Public Works (1897) Department.

Come here at Wellington: Mr S.E. IV Civil
requested to submit an estimate for the
extension of the — on the lines suggested in
the Engineer's report No 3795 of 27. Sept 1897

Letter from the Executive Engineer Coimbatore Division to the Superintending Engineer Fourth Circle No 3795 dated 27th September 1897.

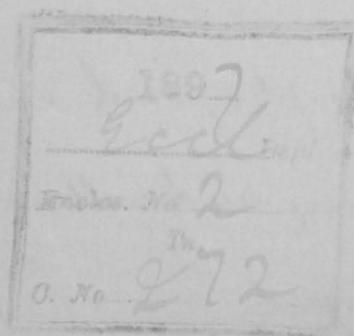
In returning the enclosures by your No 491 dated 16th August 1897, I have the honor to report that I consider the cemetery at Wellington should be extended to the east and the Chaplain agrees with me in this opinion. I enclose a tracing showing the eastern portion of the existing cemetery and the proposed eastern extension marked by red dotted lines.

A small additional area, can I think be obtained by correcting the alignment of the channel to the north of the existing cemetery.

I have had pits dug here and there over the proposed eastern extension and the soil at all pits is suitable for excavating graves to a depth of 6 feet.

A path or track exists close to the eastern boundary of the existing cemetery, but I understand this is not a right of way and that there is no objection to closing it.

The ground in the proposed eastern extension is somewhat uneven and will have to be levelled and terraced or sloped.

There is also a small cross drainage to be provided for.
